UNITED STATES PATENT AND TRADEMARK OFFICE

APPLICATION NO.	FILING DATE	FIRST NAMED INVENTOR	ATTORNEY DOCKET NO.	CONFIRMATION NO.
09/971,763	10/09/2001	Moo-youl Kim	P56598	4212

Office Action Summary

DETAILED ACTION

FIG. 17

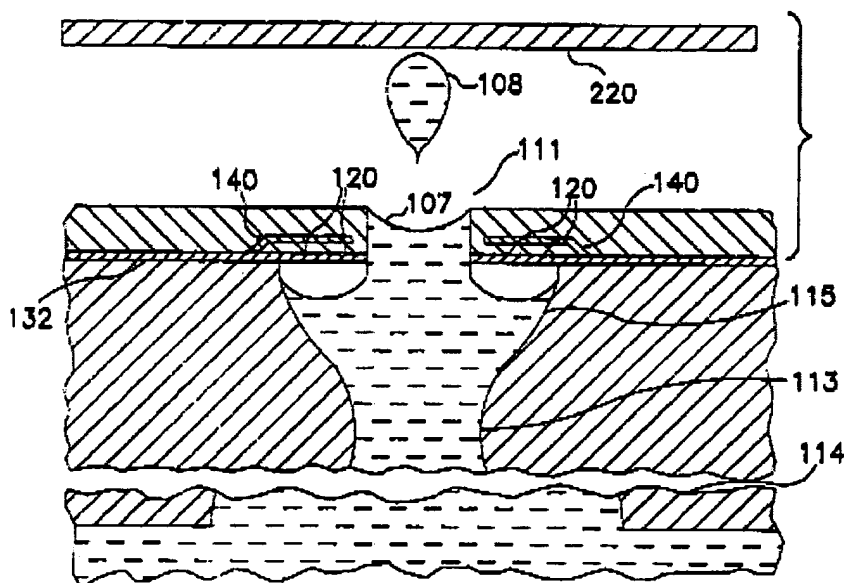
Silverbrook teaches (Fig. 17, above) an ink jet print head comprising a base plate (130), which is perforated by an hour-glass shaped structure having a hemispherical shaped top portion that is filled with ink, a nozzle plate that is mounted on the base plate and is perforated by a plurality of orifices in communication with their respective chambers, a plurality of dough-nut shaped heaters (120) disposed on the underside of

the nozzle plate and surrounding each nozzle and a plurality of ink inlet passages (113), which supply ink from a reservoir to the hemispherical hour-glass shaped chamber. As can be seen Fig. 18 (which is a reverse structure of Fig. 17), each hemispherical chamber is connected to a funnel shaped chamber (489). Since Fig. 18 is a reverse of Fig. 17, these funnel shaped chambers would be found beneath the hemispherical chambers of Fig. 17.

Silverbrook teaches the claimed invention with the exception of the ink inlet passages each having a plurality of grooves formed at an inner wall.
